**PROJECT: CSC – FINISHING KITCHENS REFIT – COWANVILLE ESTABLISHMENT
PWGSC**

Invitation number: EF236-170111/A

ADDENDUM° A-01

ADDENDUM #SA-1	
Project name: SCC- Cowansville Institution Finishing kitchens	File no: 14-13.600
Section: 11 41 11 (Division 11) Walk-in coolers and freezers	Date: 2016 07 07

Drawing I02/6

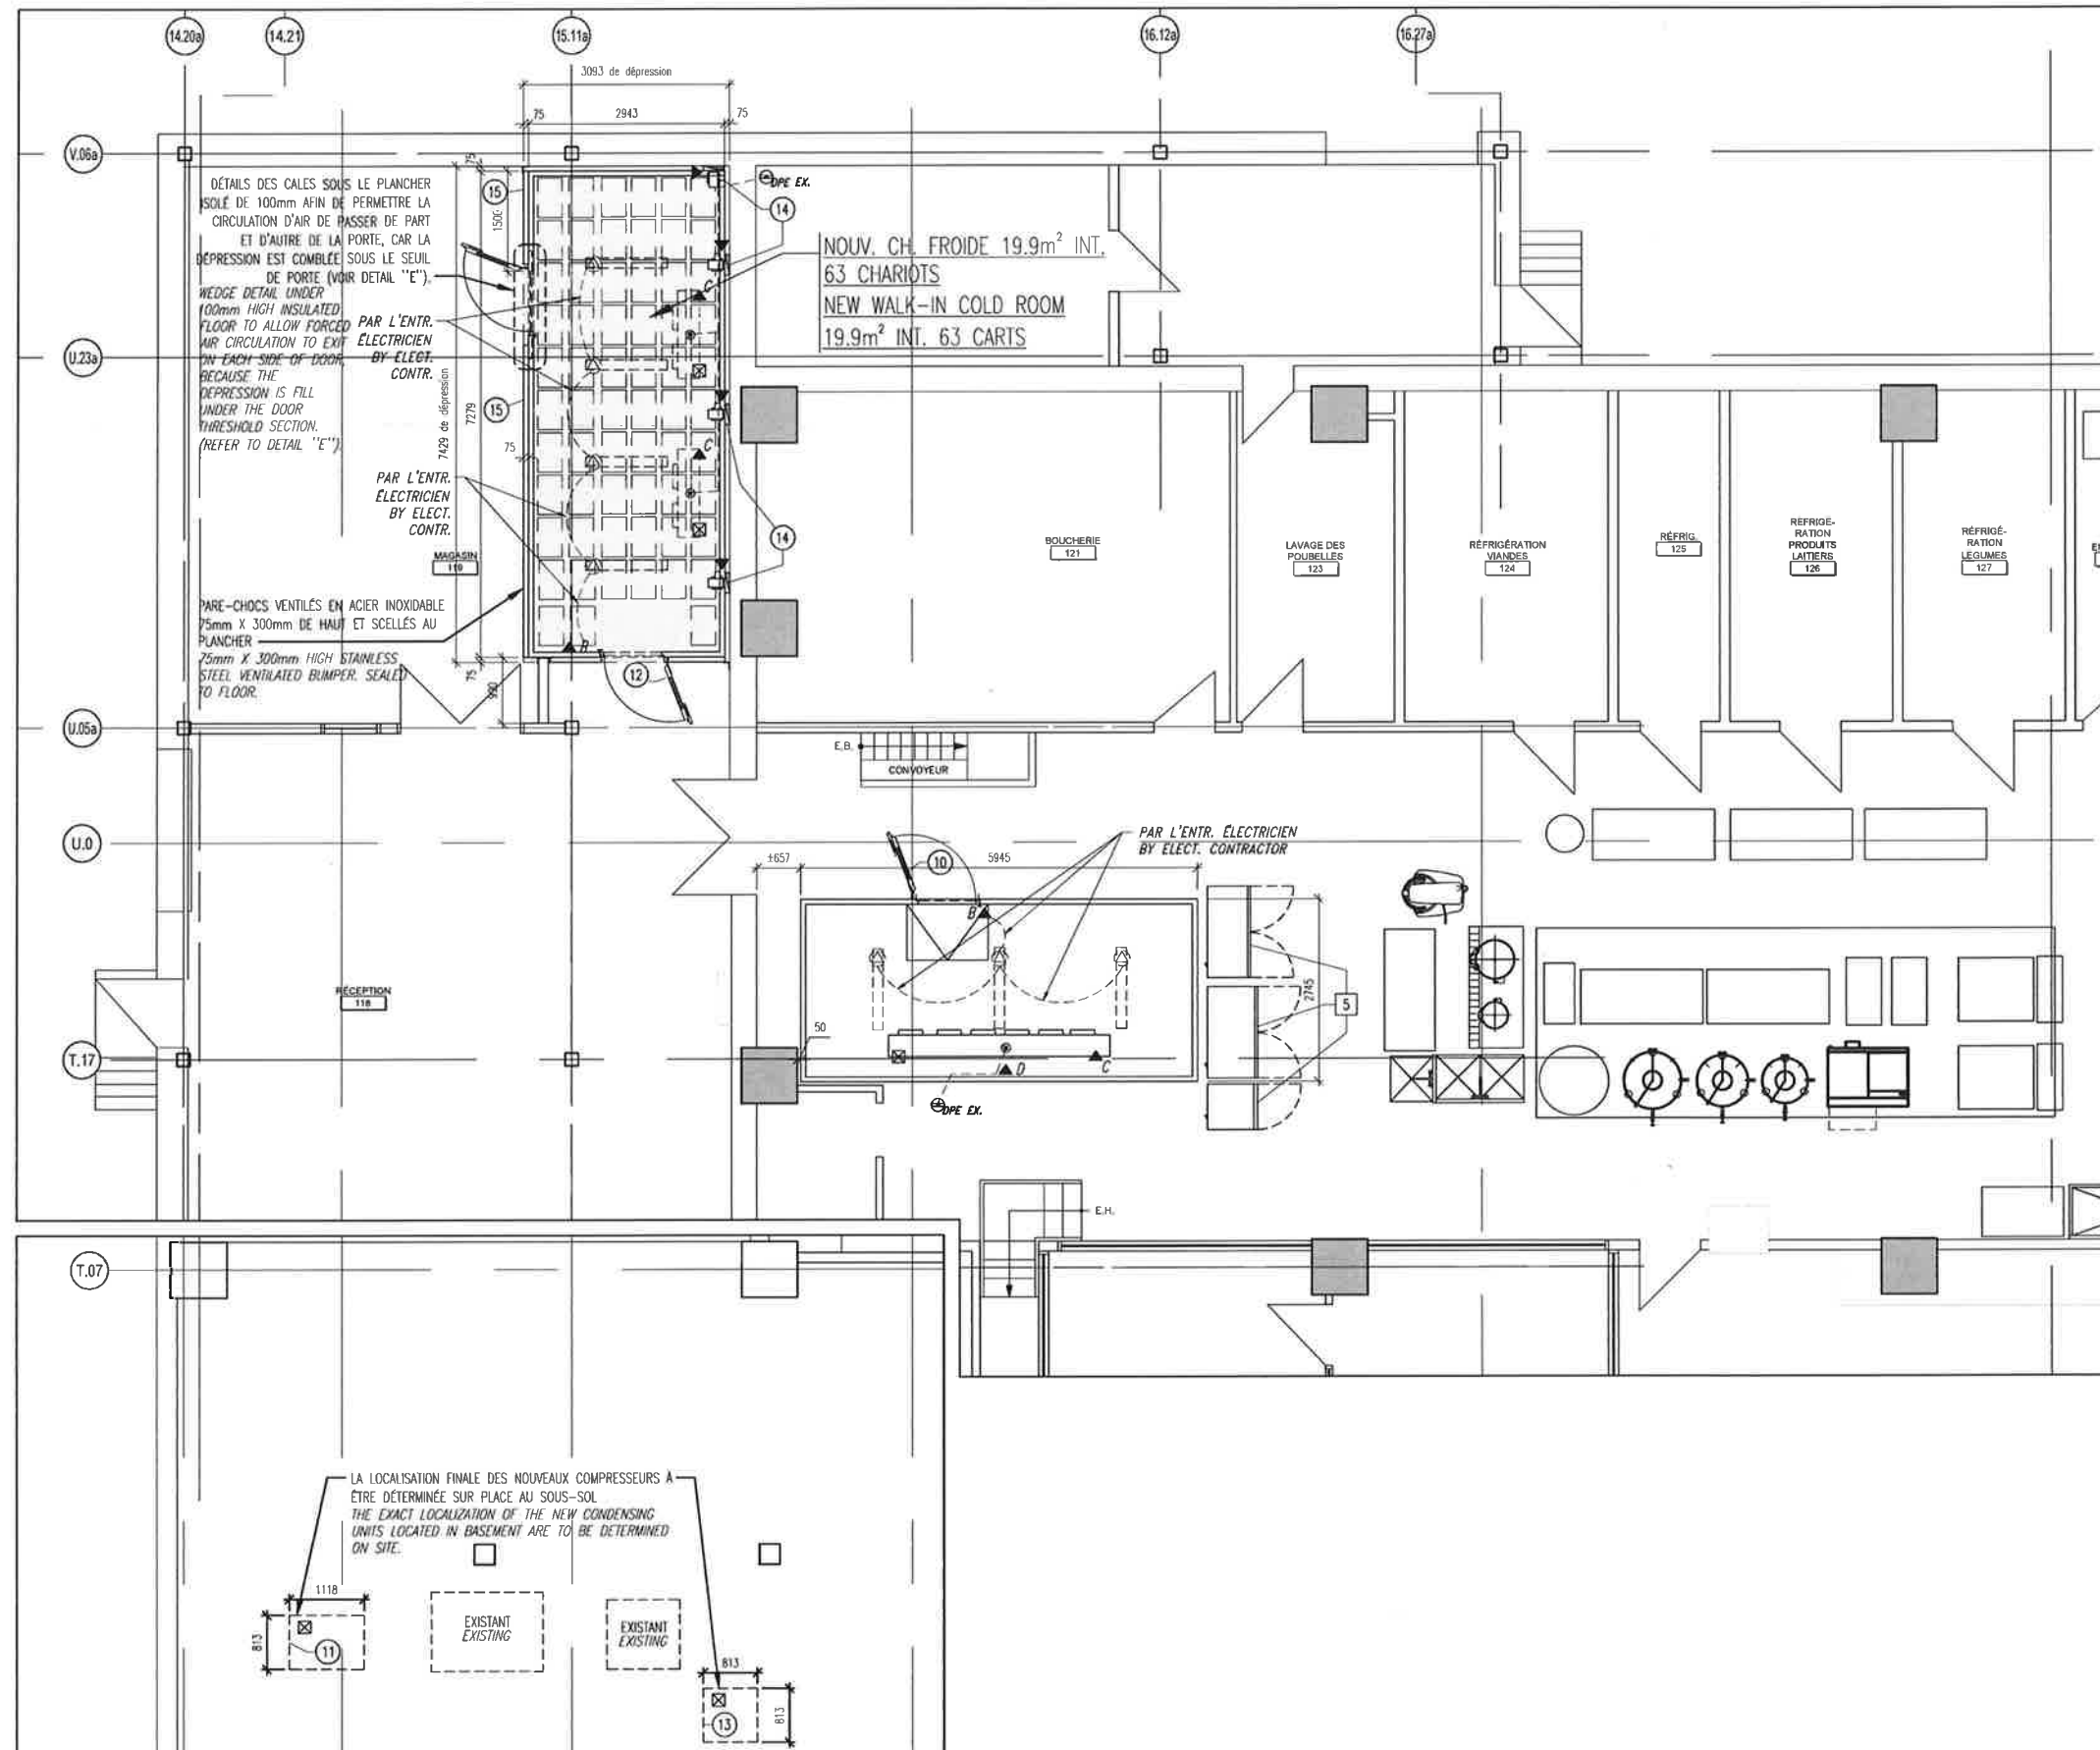
- The localization of the 2 condensing units #11 and #13 is modified. Refer to drawing I02/6 enclosed.

4 RA-1 RACCORDS MÉCANIQUES ET ÉLECTRIQUES DE CHAMBRE FROIDE
RA-1 MECHANICAL AND ELECTRICAL DIAGRAM FOR THE WALK-IN COLD ROOM

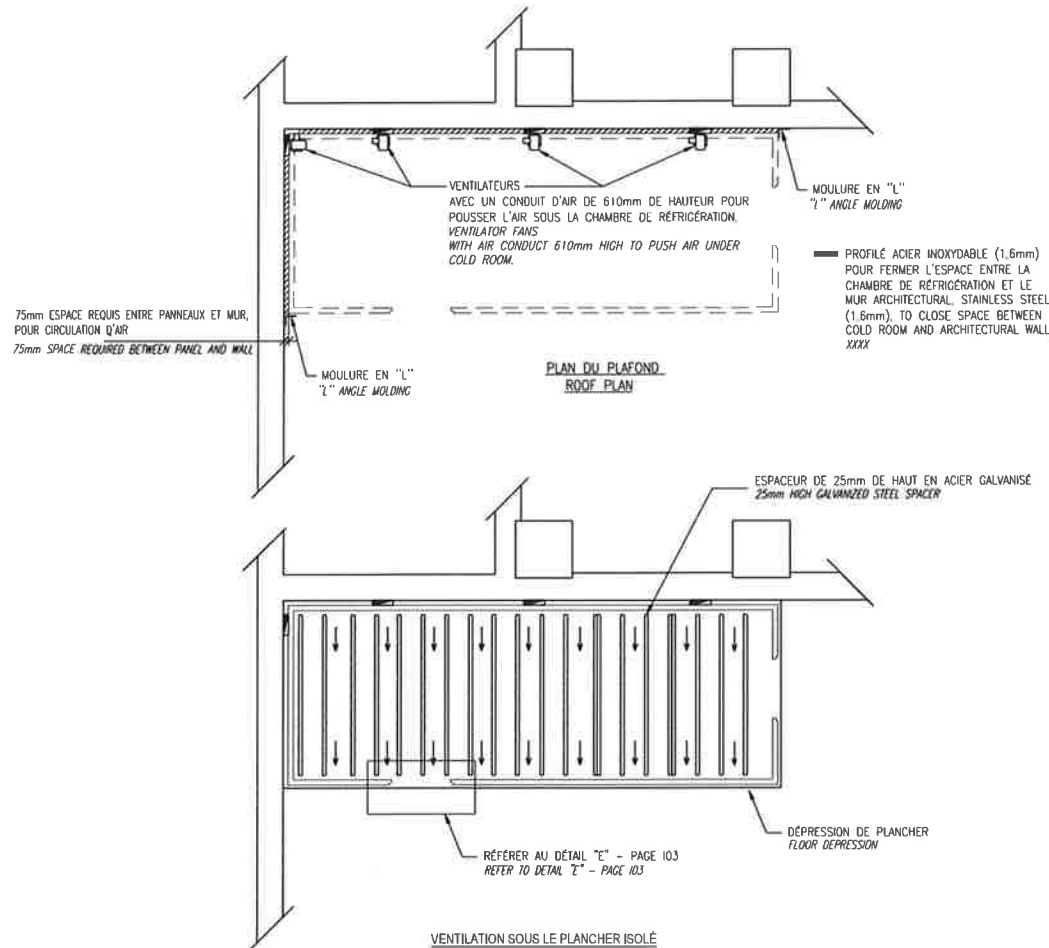
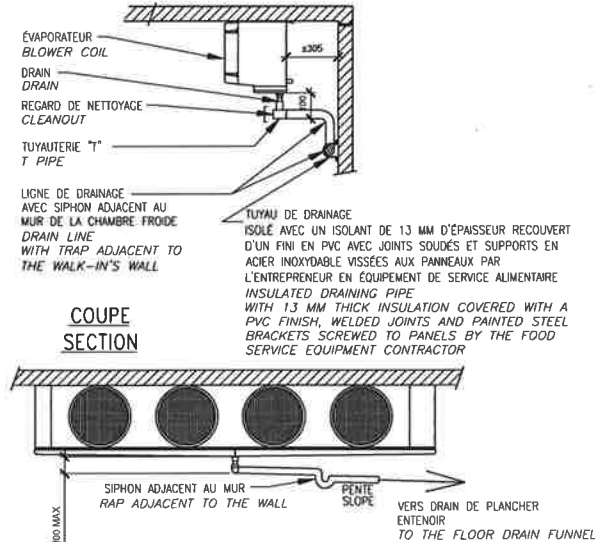
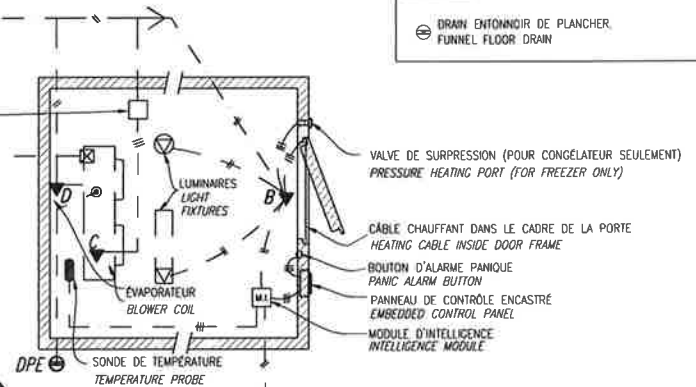
- The detail RA-1 is modified. Refer to drawing I05/6 enclosed.
